Our Ref: 80216045-CV1B-RP-001:AL  
Contact: Robert Lewis

## **MARRICKVILLE METRO S75W PROPOSED MODIFICATION RESPONSE TO SUBMISSIONS**

# APPENDIX A

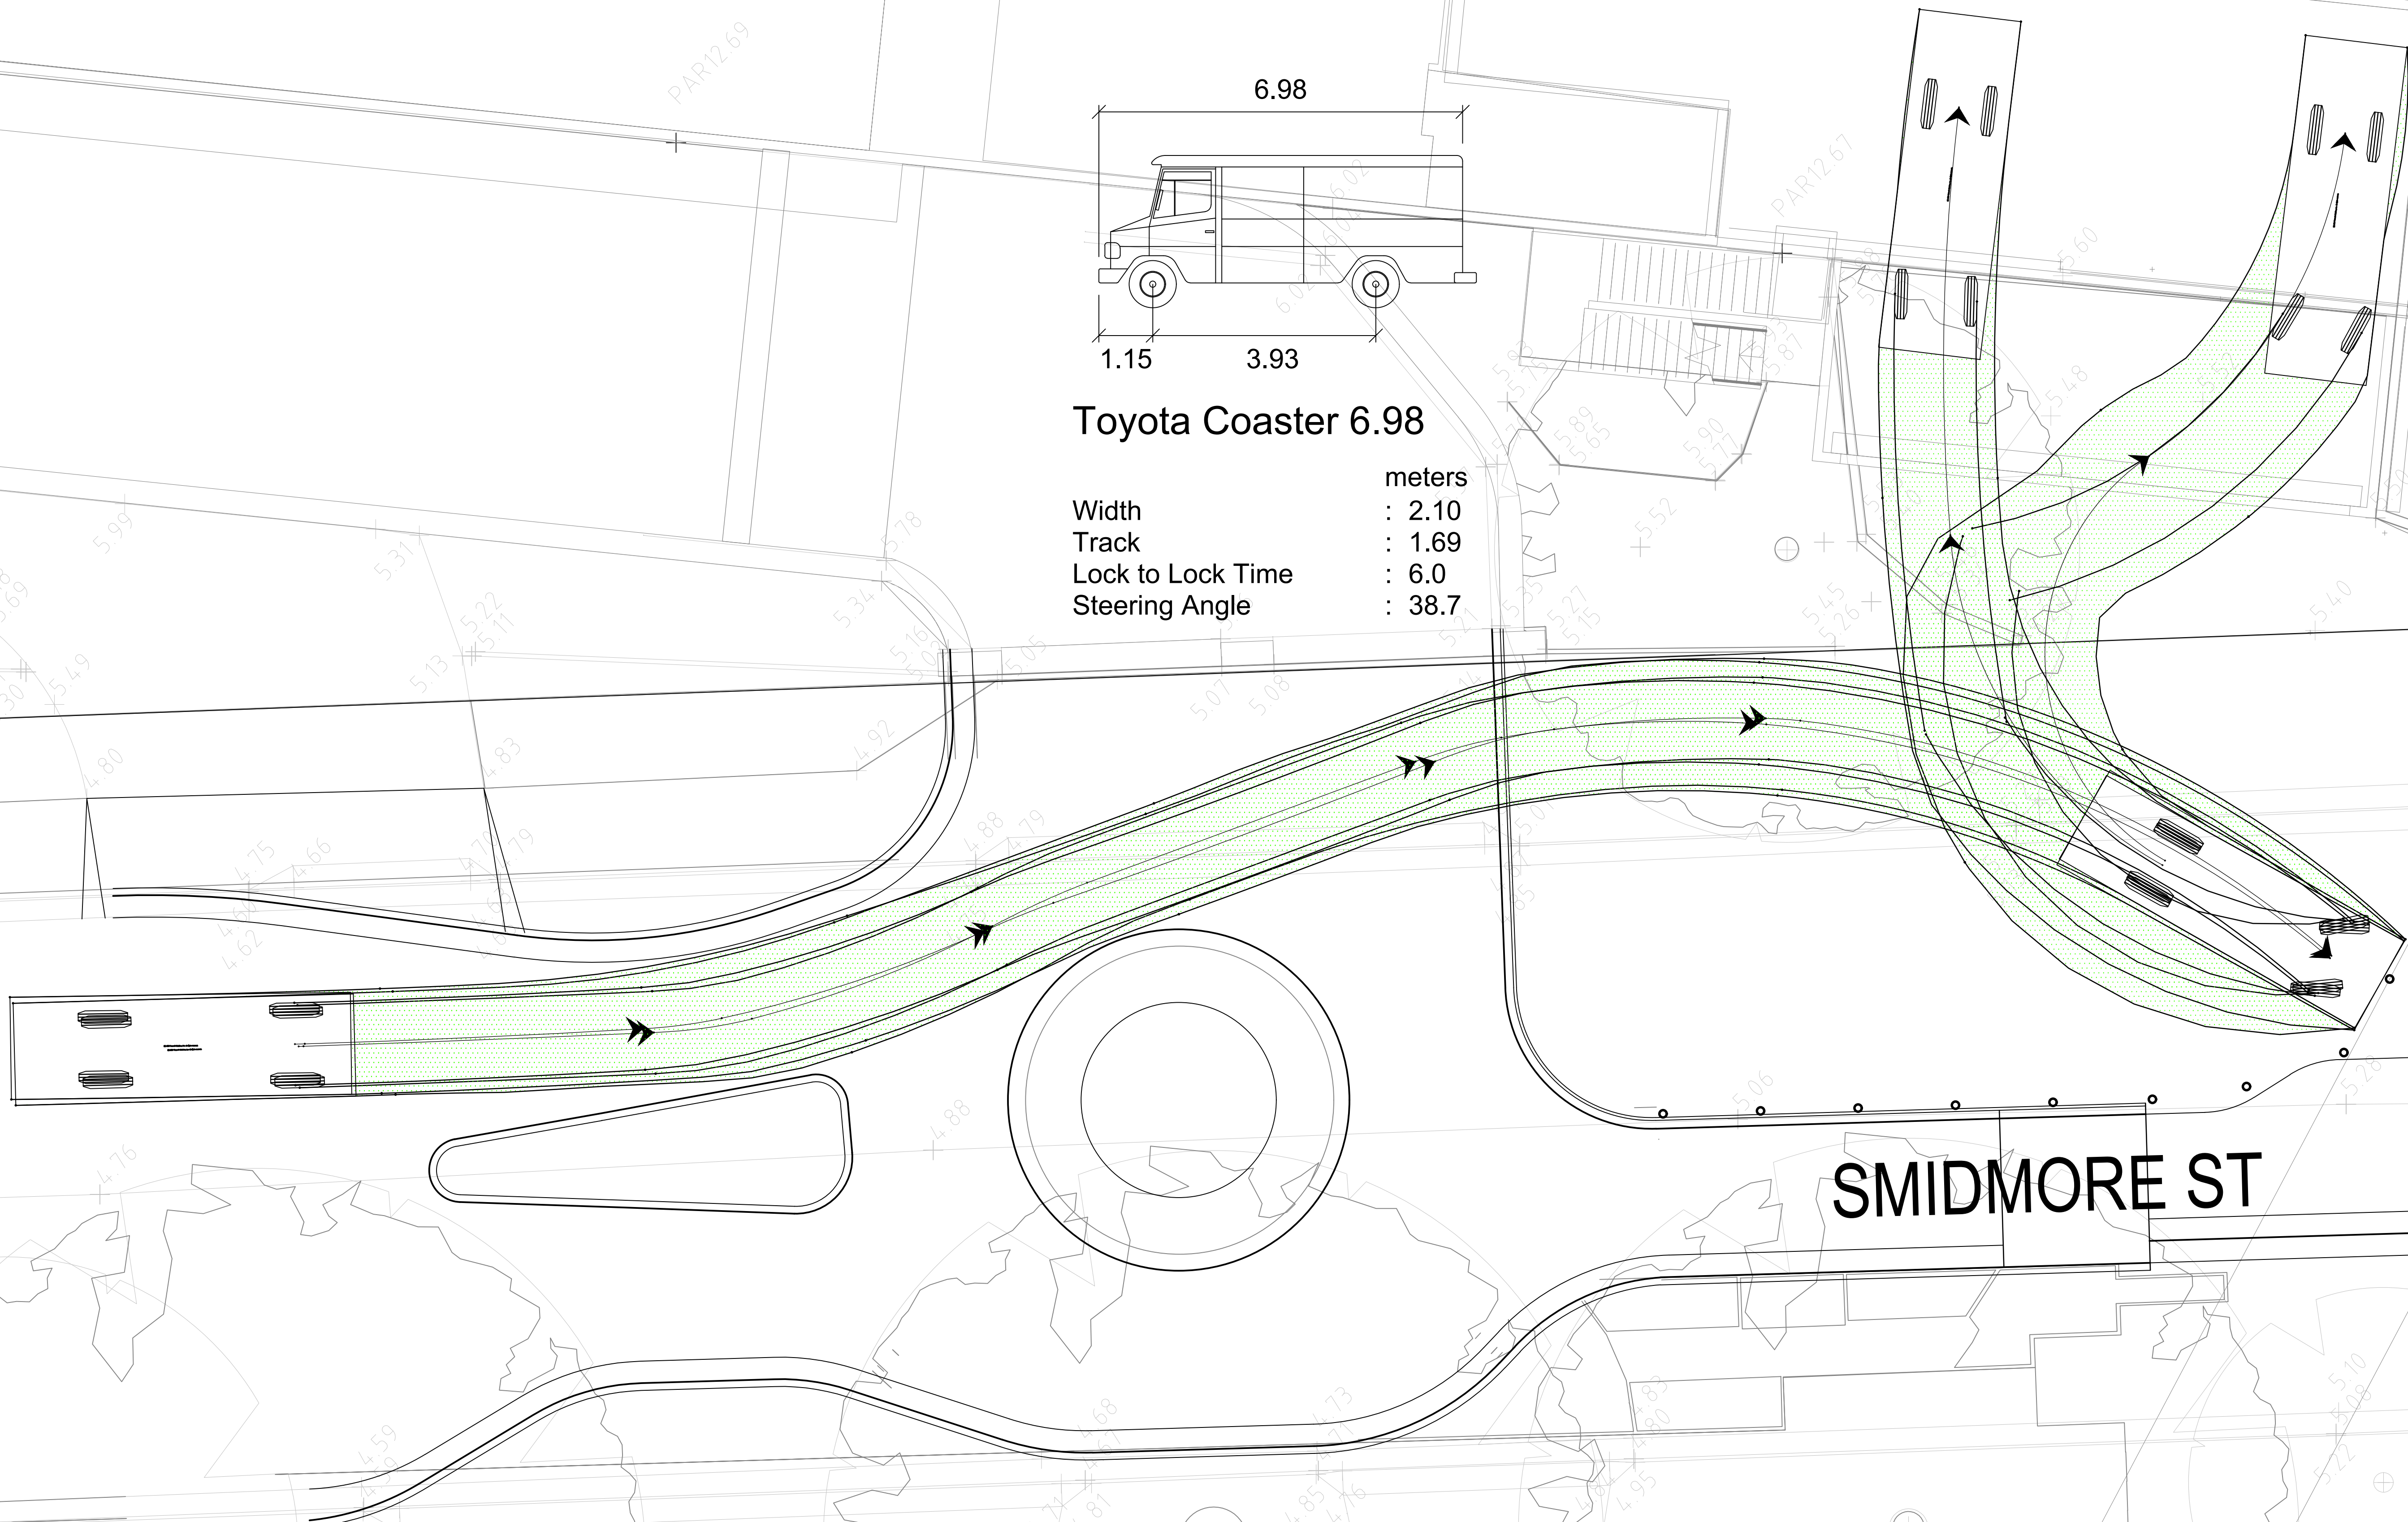
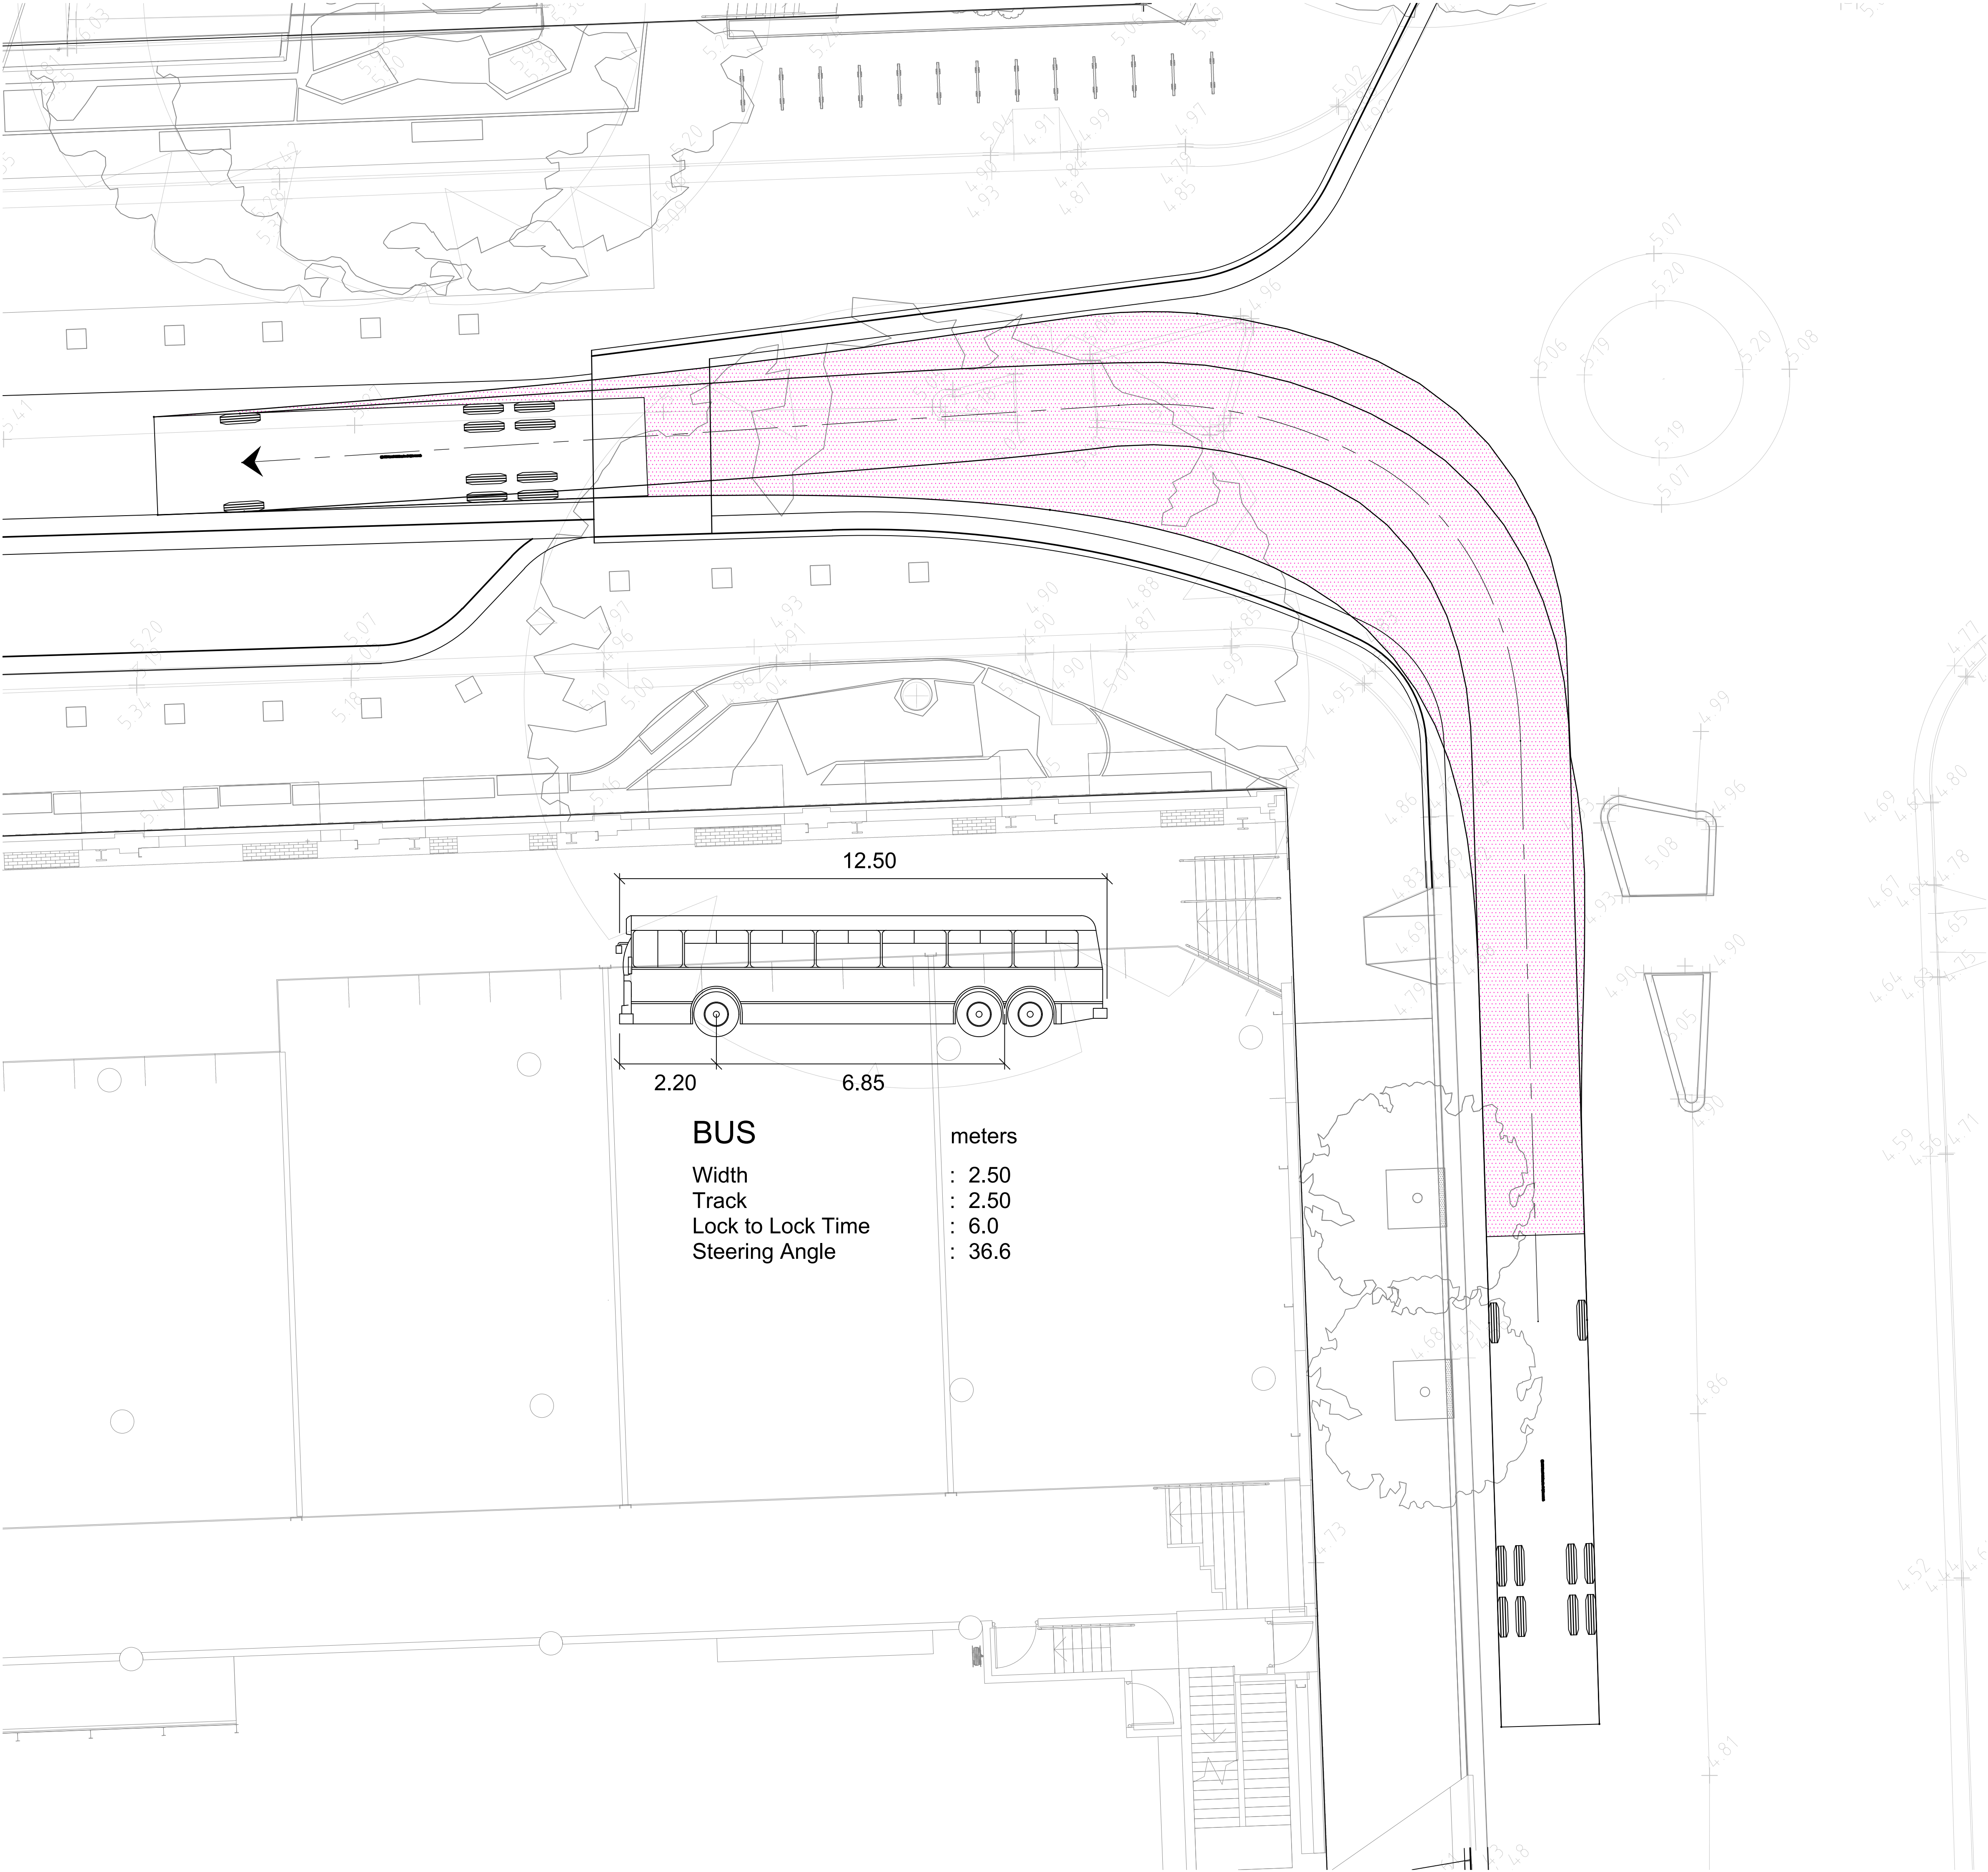
*'3. Provide additional information to demonstrate that the movement and interaction of vehicles and pedestrians in Smidmore Street can occur safely, having regard to the operation of the existing loading dock, the entry/exit ramp to the existing carpark and the roundabouts.'*

*'Swept path analysis should be prepared to demonstrate the proposed road configuration on Smidmore Street is adequate to accommodate the manoeuvring of the proposed community bus service.'*

*'The applicant should provide further information on how the existing loading dock will be operated and accessed from Smidmore Street. Swept path analysis should be prepared to demonstrate the adequacy for truck access having regards to the proposed roundabout and one-way access off Murray Street'*

*'3. Swept paths should be provided for Smidmore Street, with larger vehicles being able to manoeuvre around the roundabout without having to undertake a 3-point turn.'*

Cardno have completed turnpath analyses for various vehicles. The turnpaths demonstrate safe traffic flow around the existing entry/exit ramp and proposed roundabout by showing 99<sup>th</sup> percentile car entry, exit and U-turn movements. Refer to **Appendix A** for turnpath sketches.

The turnpaths also demonstrate that vehicles under 7m total length accessing the existing loading dock without encroaching other vehicle and pedestrian pathways. Vehicles exceeding 7m will require local pedestrian traffic control and retracting of the proposed removable bollards to access the existing Smidmore street loading dock. Refer to **Appendix A** for turnpath sketches.

Cardno have completed turnpath analyses for community bus service movements. The turnpaths demonstrate safe and adequate movement throughout proposed Smidmore Street arrangement inbound, through fare and outbound movements. Turnpath analysis also shows U-turn movements for community buses at the proposed Smidmore Street roundabout. Refer to **Appendix A** for turnpath sketches.

The turnpaths analysis demonstrates safe large vehicles movements around the proposed roundabout by showing the community bus accomplishing U-turns. Refer to **Appendix A** for turnpath sketches.

DELIVERY VEHICLE TO LOADING DOCK BAYS PERMITTED  
ONLY WHEN REMOVABLE BOLLARDS ARE RETRACTED  
AND PEDESTRIAN TRAFFIC CONTROL IS PRESENT.
